MILNOR®	Milnor Tech Note

08BH188AT processor board replacement notes

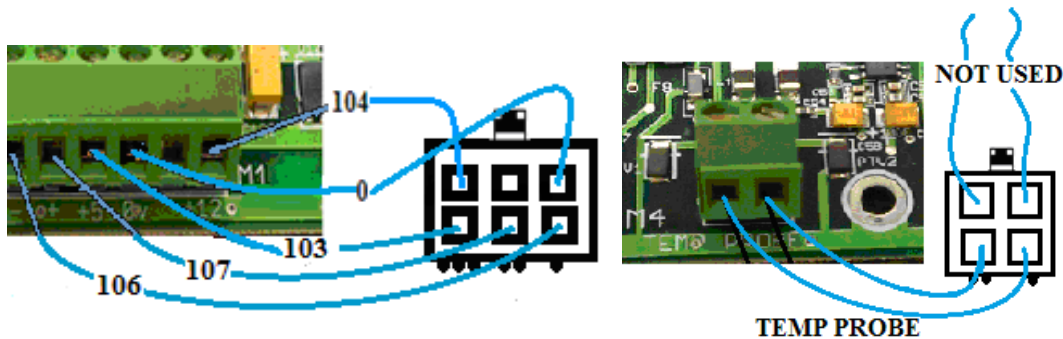
A schematic for the machine would be useful when replacing the old board, but it should be this simple...
1. The 5VDC (103), GND (0), 12VDC (104), SER- (106) and SER+(107) wires are cut from the connector M1, stripped and placed on the new board screw terminals. Cut and strip the wires one at time and connect to the new processor board.
2. The temp probe wires on M4 are cut at the connector and tied to the screw terminals at the new M4 header.
3. The 5VDC and ground wires are not used on M4 and can be cut and capped.

The EXT-SIGNAL connector is not used.

Set the 12VDC power to 12.3 volts. The new board has onboard 5VDC regulation so there is no need to adjust the 5 volt supply.

HARDWARE for mounting the new board:

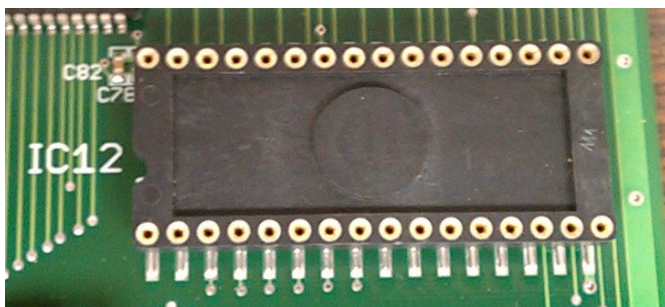
The new board is thicker than the old. The standoffs for the old board will not lock to the new board, so, screws and nuts are provided for the attachment. If you use metal screws, only use them on the edge of the new board, not in the middle.

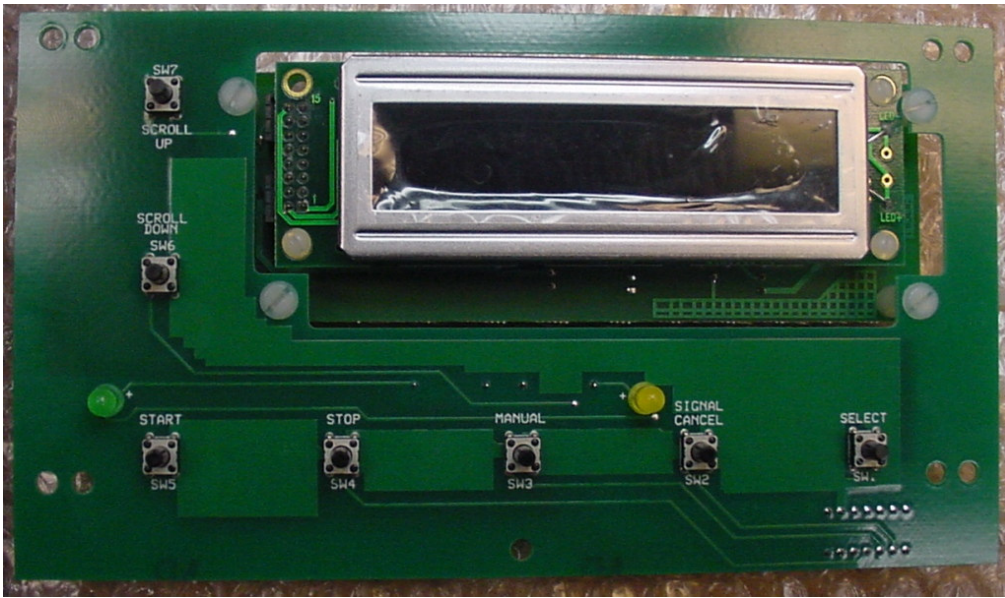
CAUTION: before applying power to the new processor board, install the EPROM (IC12) aligning the notch in the end of the chip with that of the socket and connect ONLY the power (M1), Temp Probe (M4) and the display (M22). With these connections made apply power and check the display. If the board is correctly connected and the EPROM installed correctly, the display should show normal text, typically "DIP SWITCH CHANGED NEXT TO DEFAULT 30 FORMULAS". This proves that all th wiring is correct. Remove the power to the machine and complete the wiring of the processor board.

The socket for the machine software is shown below. Be careful not to bend pins when inserting the software in this socket! Check your work!

08BHEPSPAT FRONT SIDE

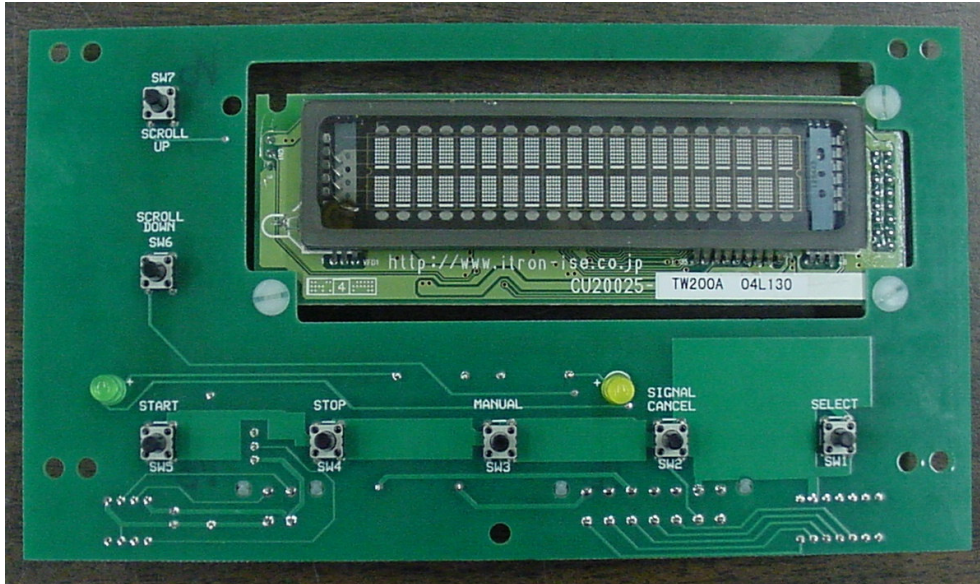
This board can be handled just like the 08BHEPSPBT board below.

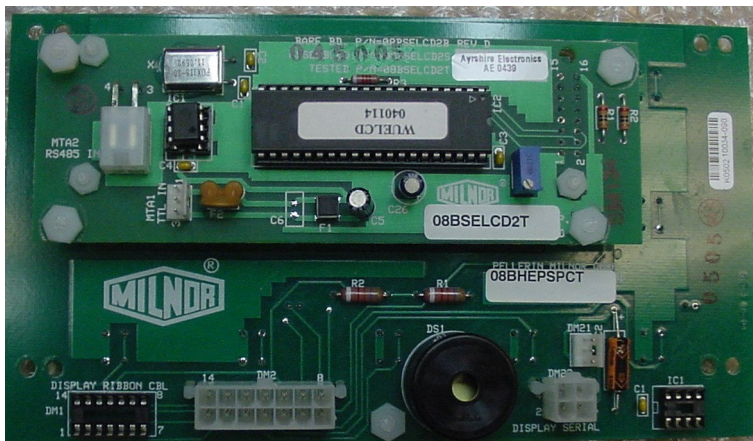
08BHEPSPBT BACK SIDE - This board has both a RS 485 connector and a TTL connector. If the previous processor was wired with a TTL cable, you will need a RS485 cable and also to jump the TTL wiring from the switch panel connector DM21 to the similar connector on the back of the display.
CAUTION: the TTL cable must be pinned in reverse order... pin 1 to pin 3 and pin 3 to pin 1. Otherwise the RS485 transceiver in IC1 will be destroyed.

Never connect any wires to CON2 on the display board.

If needed, add RS485 Transceiver 08CIF3696T into the IC1 socket. The TTL jumper from the Switchpanel to the LCD display is pn. 10YBHELCDS.

08BHEPSPCT BACK SIDE

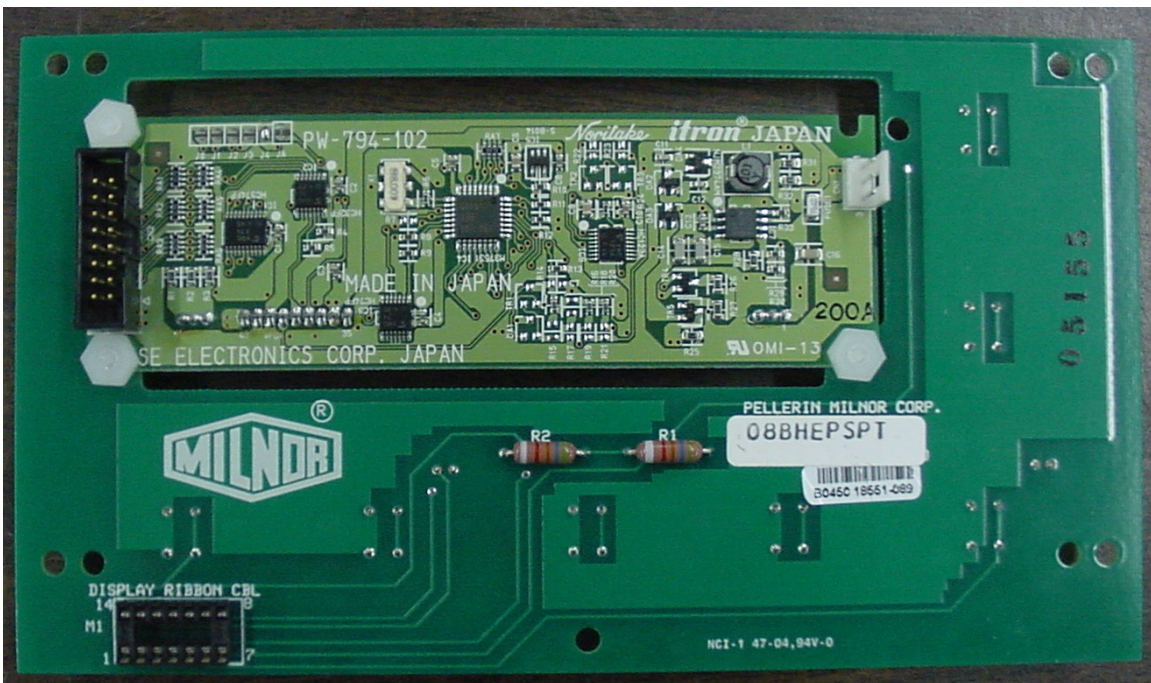
This display is compatible with all processor boards. It has both TTL and RS485 connectors. Using the 08BH188AT processor, the RS485 cable should be plugged directly onto the back of the display (MTA2) rather than onto the switch panel board. You must also remove the TTL jumper wire between the display and switch panel board. Also make sure that the transceiver is installed on the display board IC1.
